# Access Compliance Report

## Public Rights-of-Way

### (Curb Ramps)

Intersection ID: 27595	Main Street: BALLANTYNE COMMONS PY	Cross Street: BALLANTYNE MEADOWS DR	Location: NW
ADA ID: C7DF830D9F42	Ramp Type: Perp	Initial Pass/Fail: Fail	Overall Compliance: No
Severity Score: 21.25			
Codes/Mitigation Info/Possible Solution		Field Measurements/Component Compliance

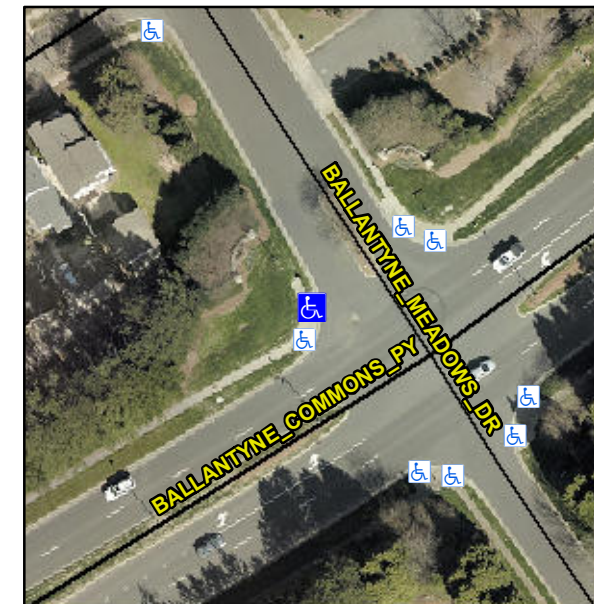
**Not Found, R304.5.1, R304.2.2**

Compliance	Description	Data	Compliance	Description	Data
N/A	Ramp Length (in)	109.0	No	Ramp Slope (%)	9.0
No	Ramp Width (in)	40.0	Yes	Ramp XSlope (%)	1.4
N/A	Flare Type LT	N/A	N/A	Flare Type RT	N/A
N/A	Flare Slope LT (%)	N/A	N/A	Flare Slope RT (%)	N/A
N/A	Flare Traversable LT?	N/A	N/A	Flare Traversable RT?	N/A
N/A	Landing Length (in)	N/A	N/A	DWS Provided?	N/A
N/A	Landing Width (in)	N/A	N/A	DWS Contrast?	N/A
N/A	Landing Slope (%)	N/A	N/A	DWS Length (in)	N/A
N/A	Landing X Slope (%)	N/A	N/A	DWS Full Width?	N/A
N/A	Landing Curb? (Y/N)	N/A	N/A	DWS Offset (in)	N/A
N/A	Shared Landing?	N/A			
N/A	Gutter Ponding?	N/A	N/A	Gutter Slope (%)	N/A
N/A	Gutter Lip Ht (in)	N/A	N/A	Gutter X Slope (%)	N/A
N/A	Painted X Walk1?	No	N/A	Painted X Walk2?	N/A
	X Walk 1 Direction	To NE		X Walk 2 Direction	N/A
N/A	X Walk 1 Width (in)	N/A	N/A	X Walk 2 Width (in)	N/A
	X Walk 1 Slope (%)	3.2		X Walk 2 Slope (%)	N/A
	X Walk 1 X Slope (%)	1.1		X Walk 2 X Slope (%)	N/A

**Remove & Replace Entire Ramp.**
